# REMUND FARMS PHASE 5 RESOLUTION 2022-34

MASTER PLAN AMENDMENT

### PROPOSED AMENDMENT

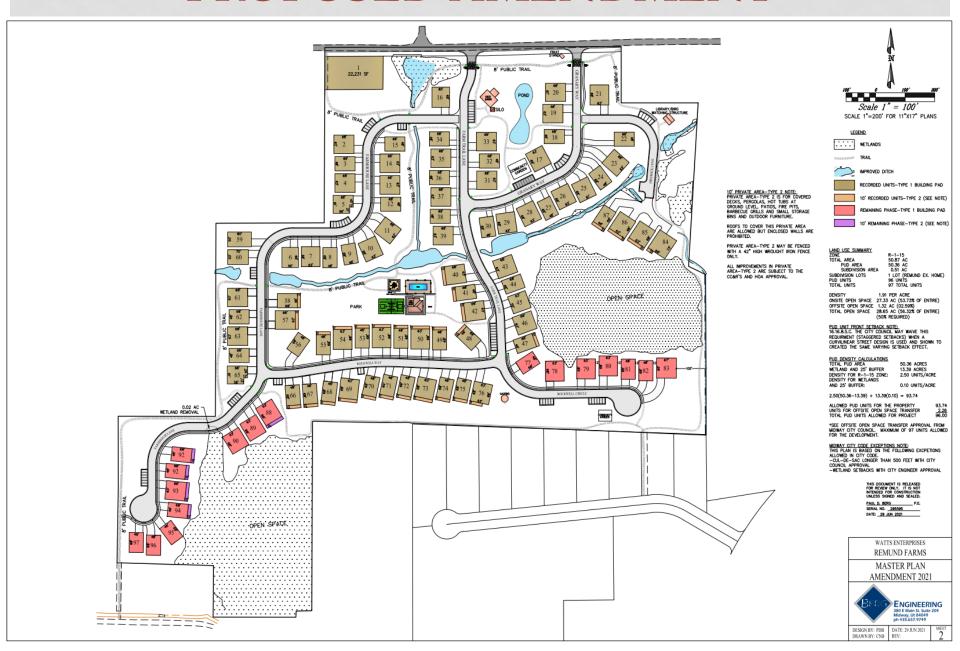
- Proposed amendments
  - Adjust the pad dimensions for units 91-97. Some units become larger, and some become smaller
    - Adjustments to the seven footprints result in an overall footprint square footage increase of 2,613 SF (0.06 acres)
  - Proposed adjustments result in some units encroaching closer to wetlands. No units will encroach into wetlands
  - Setback from south property line for units 96 &97 will remain at 42'

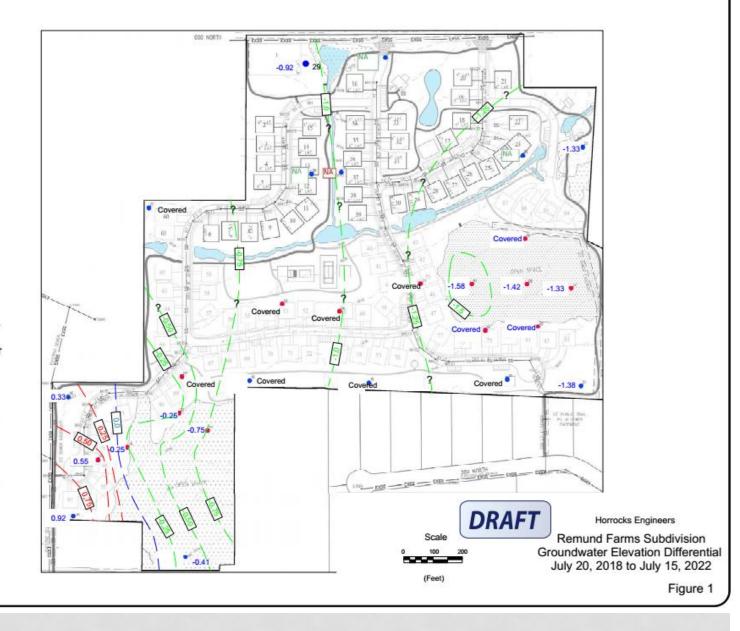
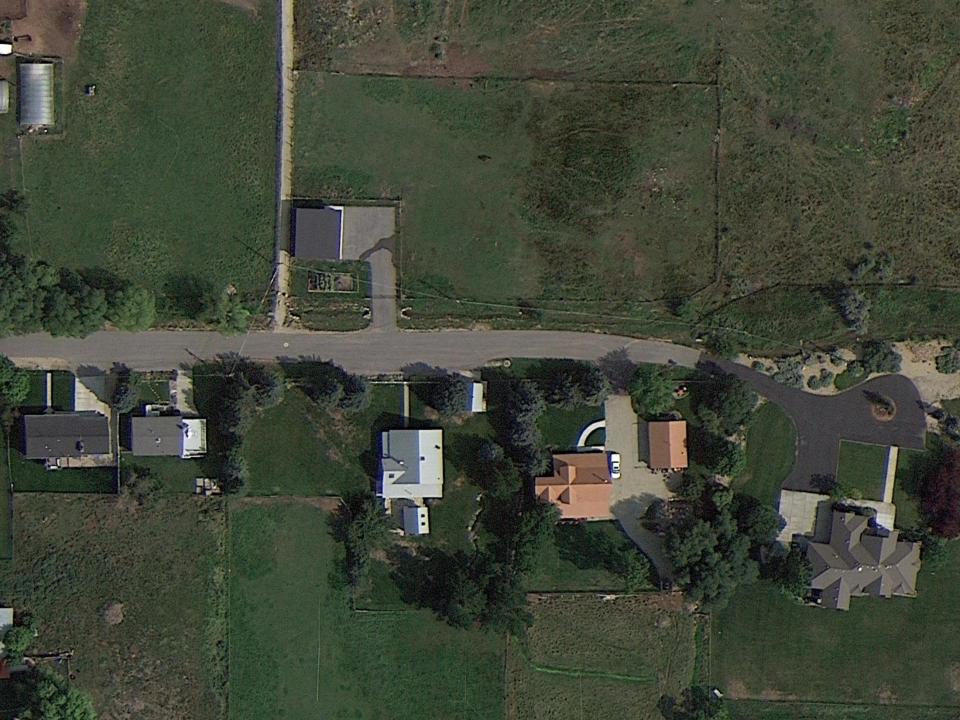
- Unit 96 fixed by keeping the setback at 42 feet. (Phase 5)
- The water issues reviewed to determine in they should be dealt with now or later and how they would be monitored and prevented over time. (Phase 5)

- 1. The applicant will survey the boundaries of the wetlands and then install temporary construction fencing when the site improvements begin for phase 5 as well as when homes are constructed in phase 5.
- 2. The developer will accept all liability for water table level variations associated with the development.
